**CITY OF NAPOLEON
BUILDING CONSTRUCTION PERMIT
(1, 2 or 3 Family Dwelling)**

Street No. 140 Glenbrook Court

Permit No. 507-76

DATE 5-3-76	JOB NO. 507-76
PROJECT NEW SINGLE FAMILY DWELLING	
LOCATION 140 GLENBROOK COURT	
CONTRACTOR BECK CONST.	OWNER R. BECK
WEATHER	TEMP. ° at AM ° at PM
PRESENT AT SITE	
ADDENDUM "B" TO PLAN APPROVAL

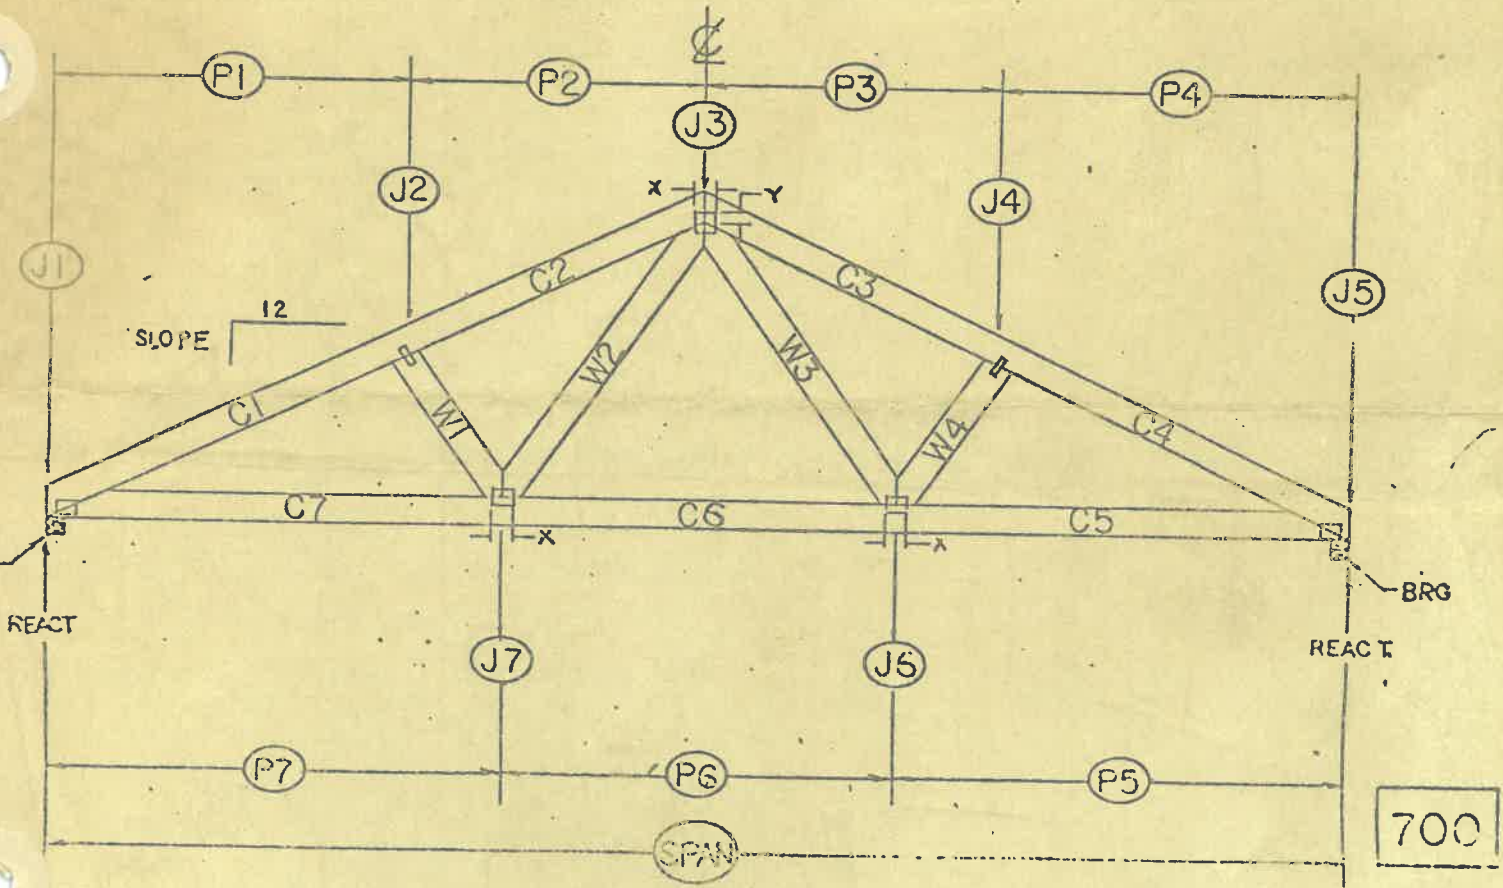
- 1) PRIOR TO INSTALLATION SUBMIT 2 COPIES OF EITHER TRUSS ^{RECEIVED 4/16/76} DATA (SEALED) OR CROSS-SECTION OF CONVENTIONAL FRAMING.
- 2) PRIOR TO INSTALLATION ^{RECEIVED 4/15/76} SUBMIT 2 COPIES OF PLUMBING DRAINAGE ^{RECEIVED 4/15/76} SPECIFIC.
- 3) PROVIDE NOT LESS THAN 100 SQ. IN. NET FREE AREA VENTILATION IN ATTIC AREA.
- 4) PROVIDE NOT LESS THAN 692 SQ. IN. NET FREE AREA VENTILATION IN CRAWL SPACE AREA.
